Subject: Continued item – San Miguel Community Plan Update / LRP2010-00016

Response to Comments (At 10/27 Planning Commission through 11/9)

San Miguel Plan review comments: October 18, 2016

Land Use Map

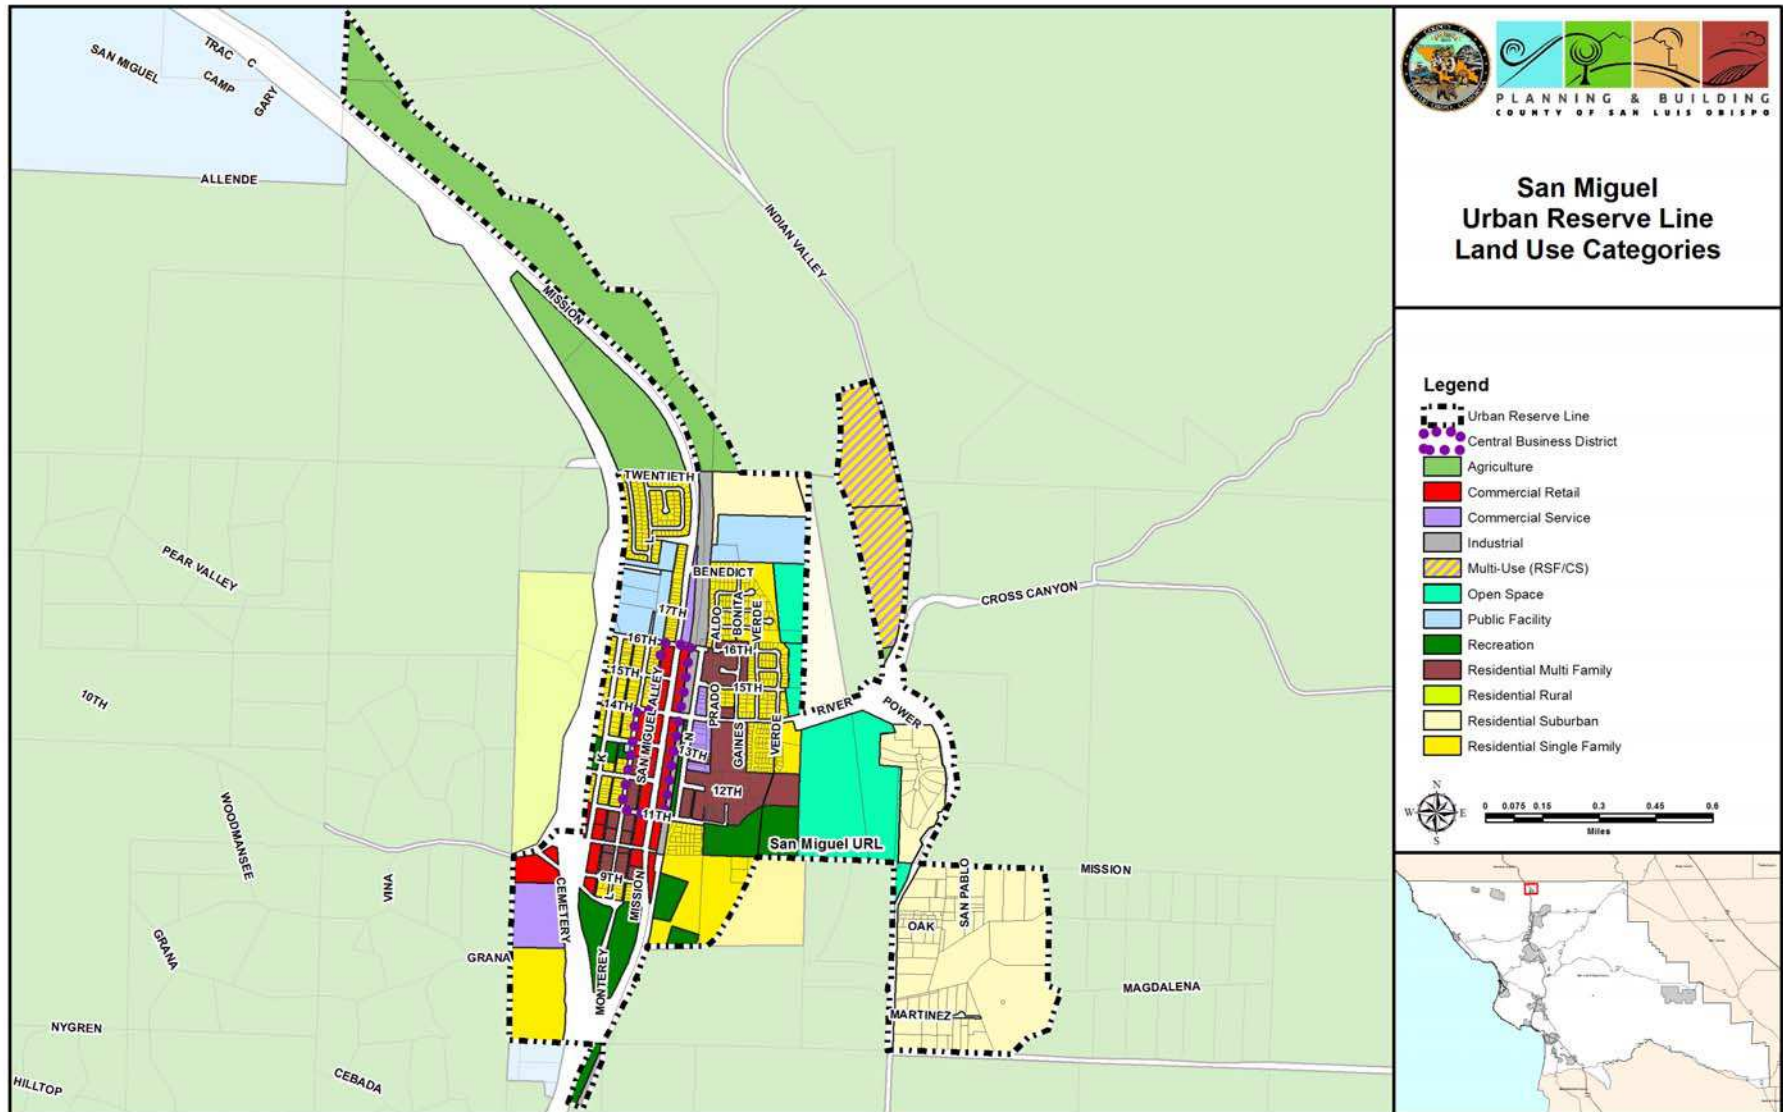
- (A) Multi-family residential development is not appropriate along N Street, particularly on the west side (Recreation zone) adjacent to the railroad.
- (B) The land use plan (Figure 3-B) shows more area in Residential Multi-Family zoning than what the plan describes.
- (C) The overall density in the Concept Plan appears to be more than the community would like.

Ms. Buckman correctly points out that Figure 3-B is inaccurate in its depiction of Residential Multi-Family zoning. The following modifications are required to accurately reflect the contents of the plan.

2. Figure 3-B. on p/ 3-7
 - Color coding is an issue: all of river area should be open space, not agriculture. That's one of many reasons I think the river should be identified. Perhaps that is an EIR issue now to change, but I would think that Environmental groups and Ag would not want agriculture occurring in the river bed.

- (A) A planning area standard could be added to prohibit residential development along the west side of N Street.
- (B) Figure 3-B does not accurately reflect the land use designations described in the community plan and requires revision.
- (C) The Concept Plan is the best representation we could develop of a mixed-housing development that also meets the community's design goals.

- Several parcels on the east side of N Street between 12th and 14th Street should be shown as Commercial Service (CS), not Residential Multi-Family (RMF). Only two properties on that block would be rezoned (Rose and Peoples' Self Help) from CS to RMF.
- The Chrisman property and a few adjacent parcels at the east end of 11th Street should be shown as Recreation (REC) not Residential Multi-Family (RMF). Recreation zoning was desired in this area to allow for potential visitor-serving equestrian uses adjacent to the river, while also allowing for some multi-family development.
- The "L Street Slope" area described in the Public Review Draft should be shown as Residential Single Family (RSF) rather than Residential Multi-Family (RMF). This change was

Source	Comment Summary	Response
October 18 Comment #5	Town Center Concept Plan should be changed to reflect what is planned/discussed.	We are open to feedback regarding specific edits to this concept plan.
October 18 Comment #7	Figure 3-P is confusing and appears to allow counting flood areas towards density.	We are open to feedback regarding specific edits to this image. The intent was to demonstrate a 7 unit per acre density with mixed housing. This density calculation excludes the Flood Hazard area.
November 2 Comment #2	Several comments and notes regarding Figure 3-B	Figure 3-B will be replaced with a more accurate land use plan.

Flood Hazard Map (Combining Designation)

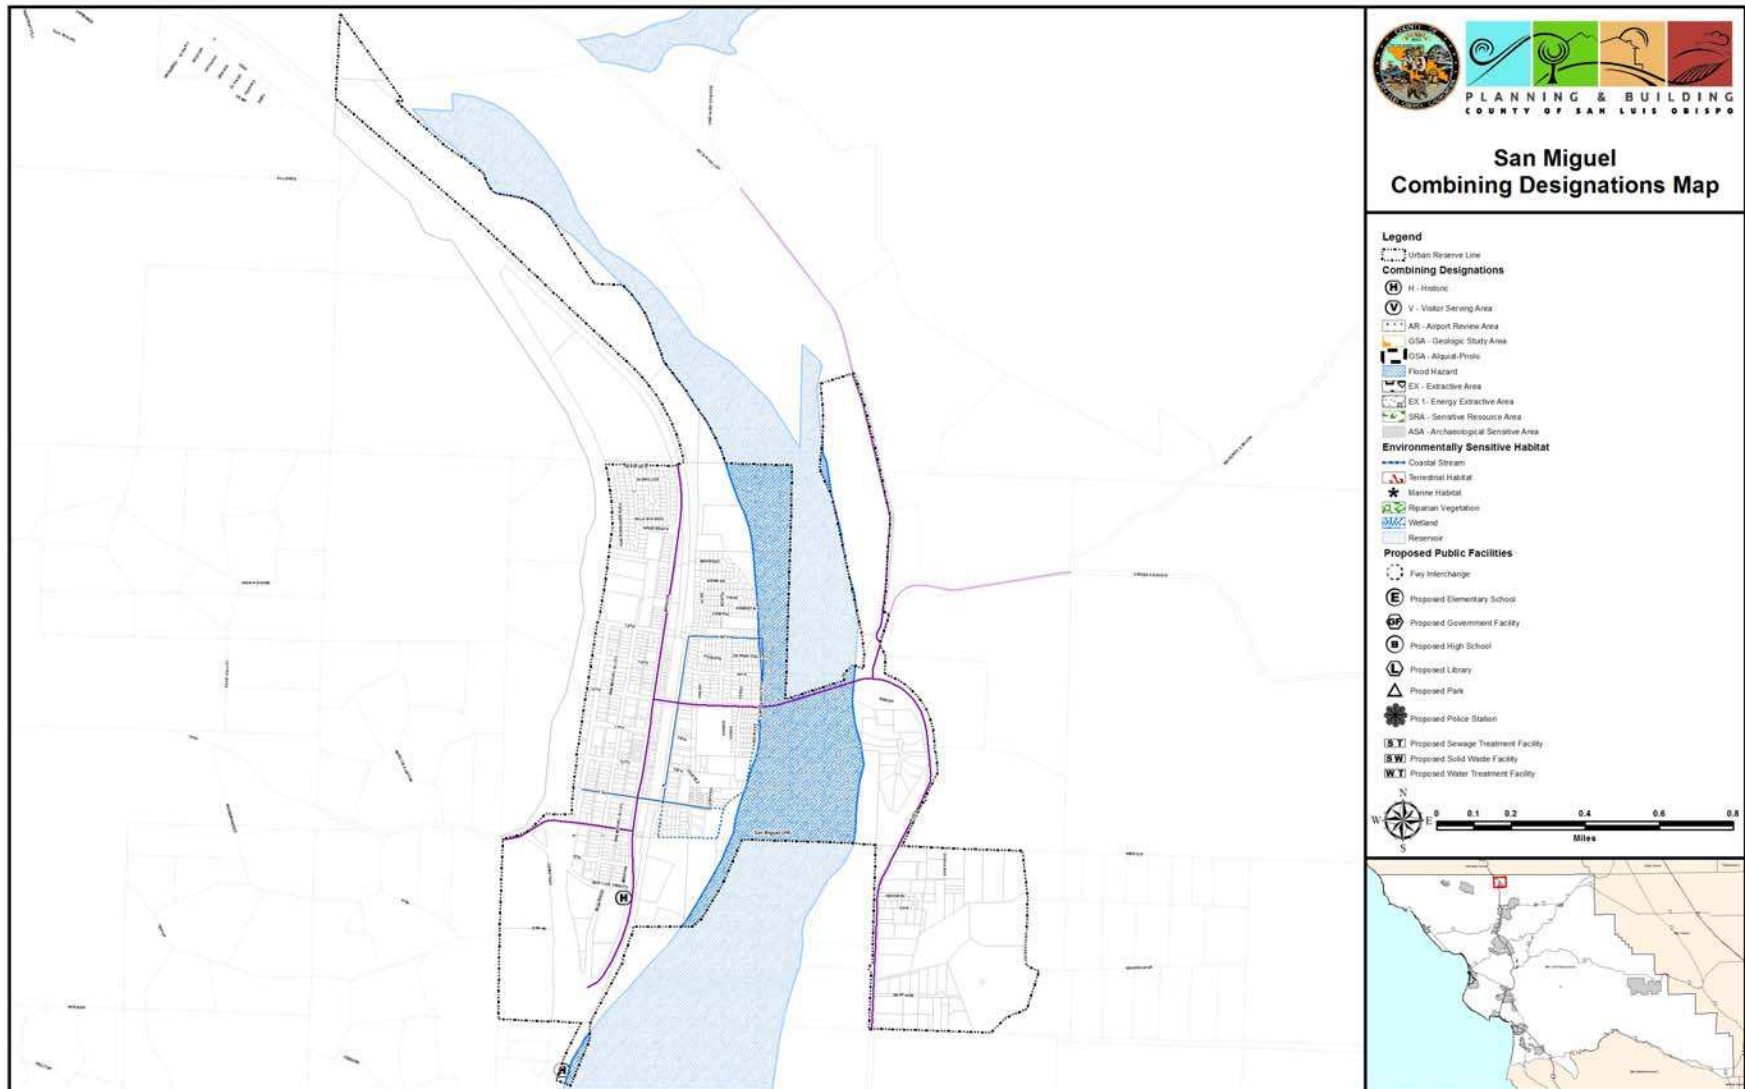
- (A) Flood Hazard areas should not be counted towards density.
- (B) It is unclear where the flood boundary actually is. Include a flood hazard map.
- (C) Development may already be approved in flood prone areas.

1. We discussed very seriously the issue of how density is calculated. Overwhelmingly consensus was that it should limit the acreage calculation by applying it only to the acreage that is NOT in the flood zone. I see that issue addressed in policies 5-01 as excluding flood hazard (FH) areas from density calculations. In discussion it was our feeling that history has told us where that flood area is and that there are maps that indicate that as well. I cannot see an indication (FH) of that boundary in this plan except for one map showing E. 11th St. and it is unclear. Unfortunately, one development has been in the works for some time and will soon be starting on land with a large portion of it in flood hazard area, so this plan will not affect it anyway. Is there a good map somewhere that indicates flood areas more specifically? It should be a part of our plan.

- (A) *Policy 3-22* in the community plan restricts using flood hazard areas towards density calculations.
- (B) *Program 4-4* in the community plan calls for the County Flood Control District to commission a new flood hazard study for the community.
- (C) Vested subdivisions may build out as approved, but they still must meet flood requirements. This often means importation of fill material to elevate lots.

CS N Street Area

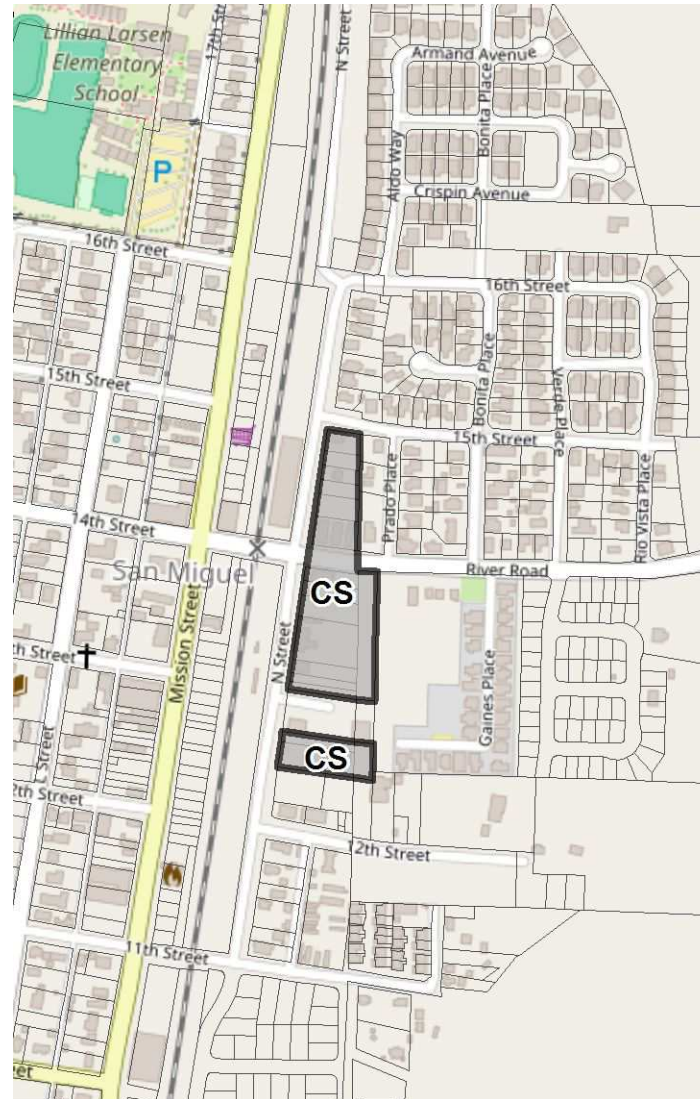
3. Figure 104-3 –CS-N St. Area under F. SD land use category, 2. N St. area : that figure shows you where the two workshop buildings exist on the Van Horn Property and you can see one of those is in that back 60' wide small strip and their property (from what I understand includes ½ of what years ago was designated as 13th st. There is a strip (I believe it is 25' wide) between the Van Horn Property and the Single Family home. That strip goes only to another 60' strip behind the RSF home and is a part of their parcel. I believe those pieces were from one of the very early maps (late 1800's, subdivision or what ever you call it). They had areas for corrals and also several blacksmith shops and related services in the area.

November 2 Comment #3	Figure 3-F doesn't include all the RSF.	Figure 3-F appears to be accurate.
November 3 Comment #3	Notes regarding Figure 104-3	Figure 104-3 will be replaced to accurately reflect CS zoning.
November 3 Comment #4	Figure 104-13 appears to be incorrect (too much RMF).	Figure 104-13 will be replaced to accurately reflect RMF zoning.
